Docket No. 52-021 MHI Ref: UAP-HF-10196

Subject: MHI's Response to US-APWR DCD RAI No. 590-4753 REVISION 0

Response to Request for Additional Information No. 590-4753 Revision 0

US-APWR Design Certification Mitsubishi Heavy Industries Docket No. 52-021

5.3.2.2 Binary Sensors

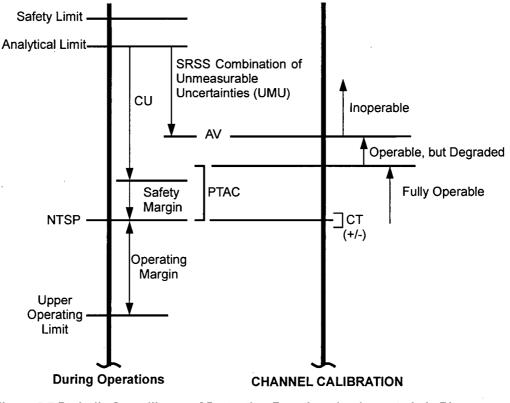
- a. Step 5.5.21.d states: "[f]or each Technical Specification required automatic protection instrumentation function implemented with an analog bistable function, performance of a CHANNEL CALIBRATION surveillance ..." MUAP-09022-P(R0), "US-APWR Instrument Setpoint Methodology," states that a Channel Calibration confirms the instrument accuracy over its entire range and that a COT confirms analog bistable accuracy. Determine the correct SR to be specified for analog bistable functions in step 5.5.21.d.

Sections 5.3.1 and 5.3.2 of MUAP-09022-P(R1) are incorrect. MHI will revise sections 5.3.1 and 5.3.2, and add a new section 5.3.2.2 with a new Figure 5-7 in MUAP-09022 (please see "Impact on DCD").

- 9. See below:
- a. MHI will revise sections 5.3.1 and 5.3.2 of MUAP-09022 and add a new section 5.3.2.2 with a new Figure 5-7 in MUAP-09022.

Figure 5-7 illustrates the relationships between the trip setpoint and other parameters for

protection functions implemented via binary sensors connected to digital PSMS channels. These functions are 1) reactor trip (RT) on turbine trip (TT) via low turbine oil pressure (pressure switch) and 2) Loss of Power (LOP) signal (UV relay).

Binary sensors connected to PSMS are surveilled the same way as analog sensors connected to PSMS, whereby channel calibration confirms the complete channel accuracy in one step for periodic surveillance, with the exception that channel accuracy is checked at the binary sensor trip setting. AV, PTAC and CT limits are therefore applied to the NTSP.

The AV is used during channel calibration to determine operability. The PTAC term is described in Section 5.4. PTAC is used (relative to NTSP) to determine degradation, thus avoiding the use of excessive tolerances as required by Reference 3.2.4 (RIS 2006-17). Plant procedures will reflect this approach (increasing process; invert for decreasing process):

• If the as-found trip value is less than NTSP + PTAC, then the channel is fully operable

• If the as-found trip value is greater than NTSP + PTAC and less than AV, then the channel is operable but degraded, and corrective action is required to restore the channel to within specifications.

• If the as-found trip value is greater than AV, then the channel is inoperable, and corrective action is required, including those actions required by 10 CFR 50.36 when automatic protective devices do not function as required.
